Ref: 2024.06002

**RE: ENVIRONMENTAL AUTHORITY AMENDMENT RESPONSE TO INFORMATION REQUEST
NOTICE**

Appendix B – Eloise Copper Mine – TD5 Raise – Response to DETSI RFI Memo (Hydrogeologist.com.au, 2025)

To: AIC Copper Pty Ltd
Email: Matt Fallon <matt.fallon@aicmines.com.au>
Date: 1 August 2025
Subject: Eloise Copper Mine – TD5 Raise – Response to DETSI RFI

Figure 2.1 Observed vs modelled scatter plot

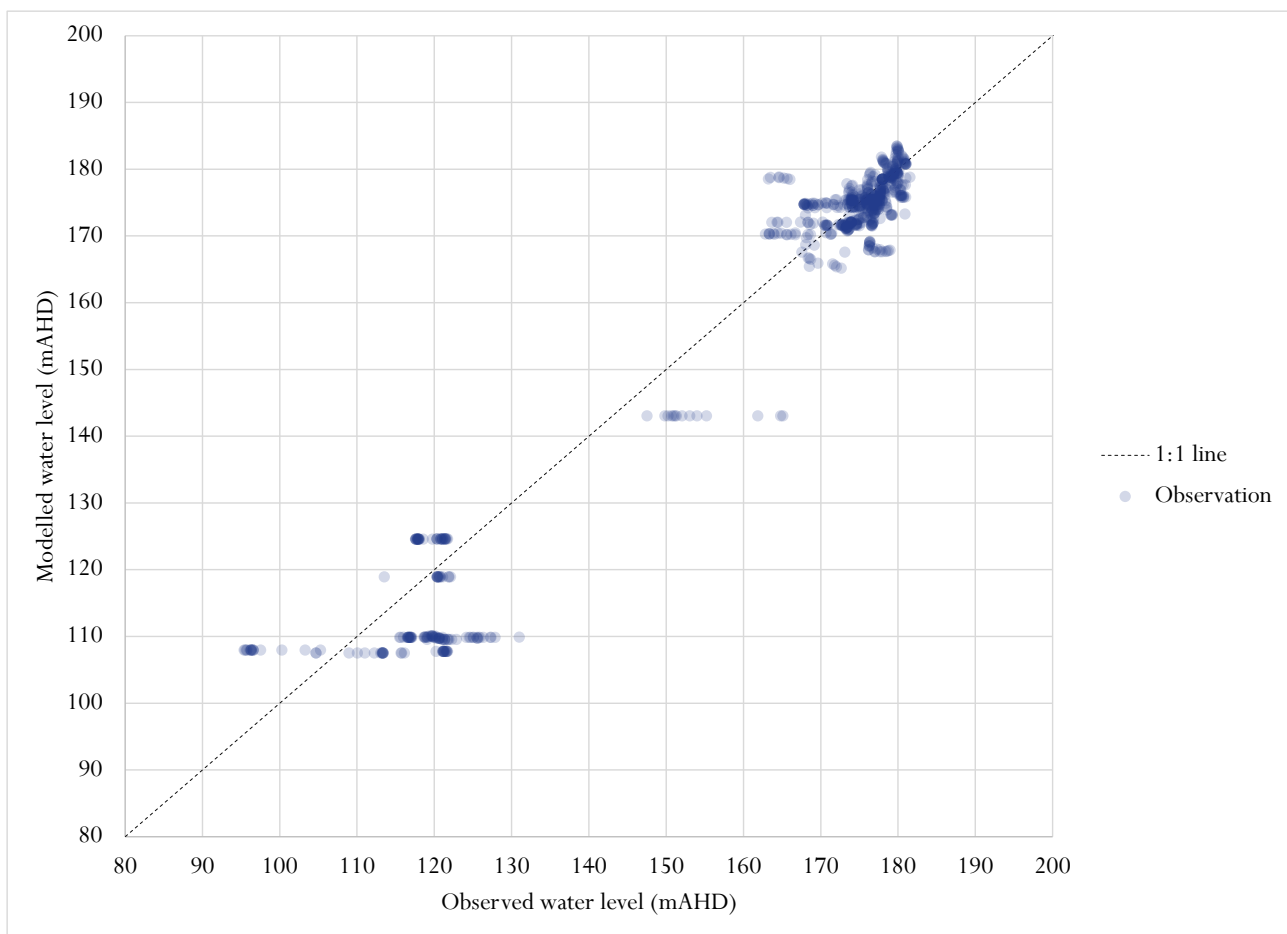
- a more robust assessment by comparing the key model outputs under both reduced recharge scenario and the disabled recharge scenario;
- an updated transient model that considers the seasonal recharge over time; and
- a revised calibration of the model taking into consideration the above matters, in addition to available seasonal data collected to date.

The recalibrated model achieved a SRMS error of 6.8% which is well below the target performance measure of 10% recommended by the Australian Groundwater Modelling Guidelines and demonstrates a very good fit to the groundwater level observations used in the calibration.

Figure 2.1 shows the scatter plot of observed vs modelled water levels. The shallow bores screened in the Tertiary sediments and upper Wallumbilla Formation show a good match, while the deeper bores with water levels below around 130 mAHD show a minor departure from the 1:1 line. The model is therefore considered to be a reliable representation of both the shallow groundwater conditions around the TSF and the deeper groundwater conditions associated with underground mining. However, the primary objective of the numerical model is to simulate shallow groundwater flow processes and impacts associated with the TSF.

As a result of the recalibration, the recharge factor, which was previously calibrated to an extremely low value of $1.43\text{E-}07$ was recalibrated to a value of $7.7\text{E-}04$ (or 0.77% of rainfall). This recalibrated recharge factor is approximately three orders of magnitude higher than the previous calibrated value.

Figure 3.2 Tertiary sediments particle path lines until end of mining

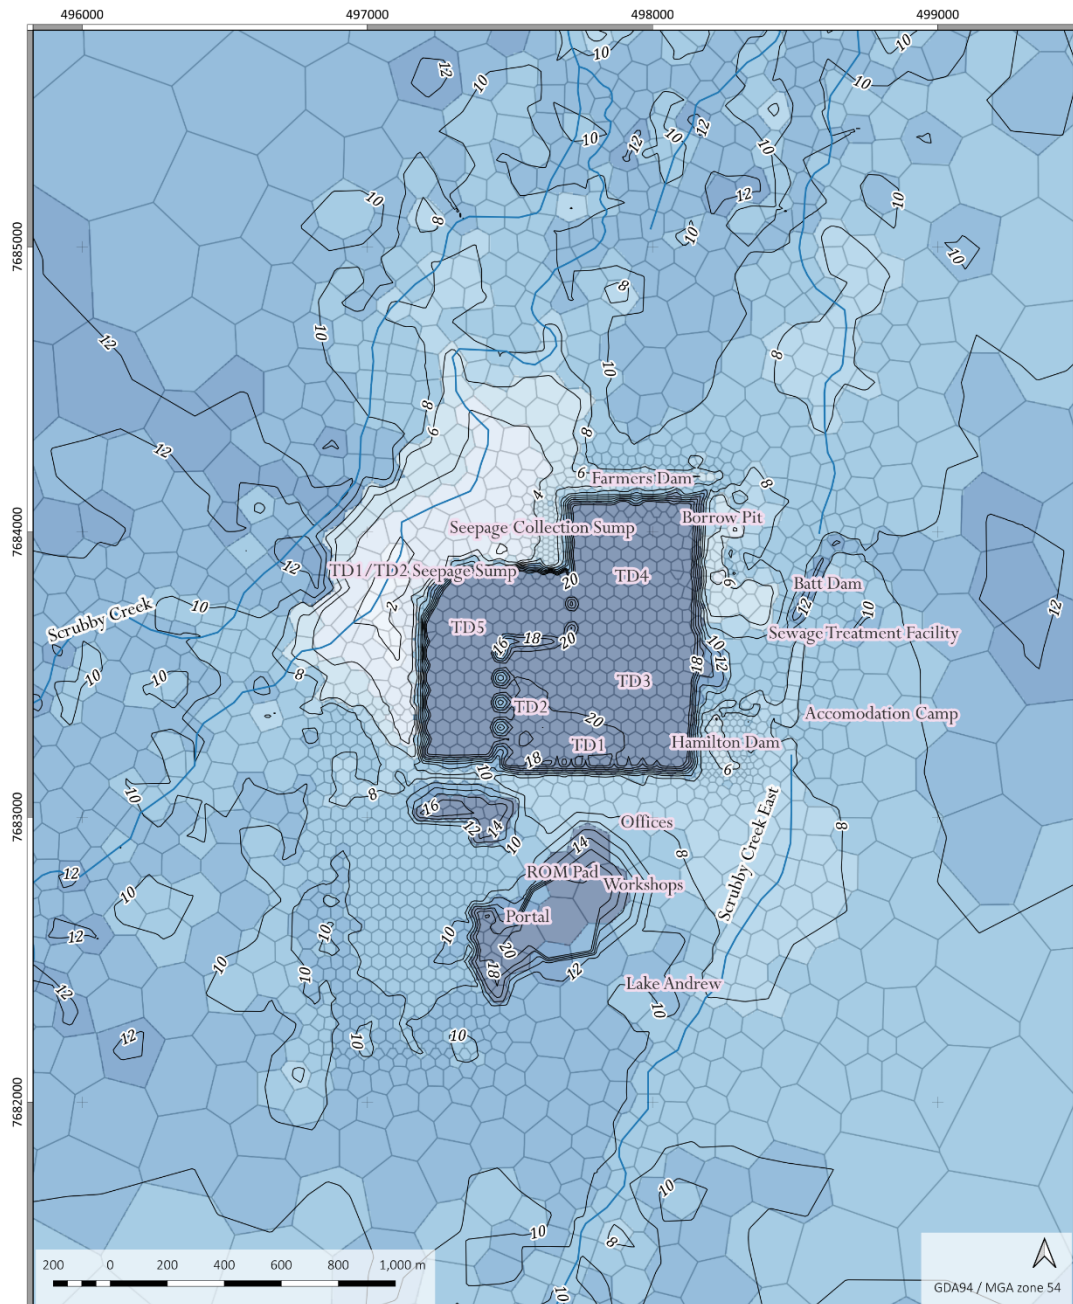
- details (e.g. direction, distance, rate, etc.) of the predicted flow path for seepage offsite; and
- justification for no surface expressions despite likelihood of shallow seepage flow path.

To assess the source of the mounded water around the TSF, particle tracking was performed using the MODFLOW-USG compatible software mod-PATH3DU¹. This particle tracking was carried out on the recalibrated model described in Section 2 above. Particles were ‘spawned’ in a regular grid with 200 m spacing around the perimeter of the TSF and seepage collection ponds. They were placed in model layer 2 (Tertiary sediments) halfway between the top and bottom of the model cell and were released on day one of the model (January 1996). Particles flowed on paths calculated from the MODFLOW-USG cell-by-cell flow file (CBB). Each layer of the model was assigned a porosity derived from the average specific yield (Sy) of that layer. Particles were allowed to terminate if they encountered drain cells (i.e. the underground portal and the drainage lines of Scrubby Creek and Scrubby Creek East).

Figure 3.2 shows the start and end points of each particle as well as the flow path for each particle. Most particles showed very little lateral movement, but movement can be seen in particles that were drawn into the underground portal, and there is some minor movement toward the mounding north-west of TD5. However, the path lines of those particles have insufficient length to have originated from seepage water from the TSF and are therefore considered to represent movement of waters upwelling into the Tertiary sediments from the Wallumbilla Formation due to hydraulic loading of the TSF.
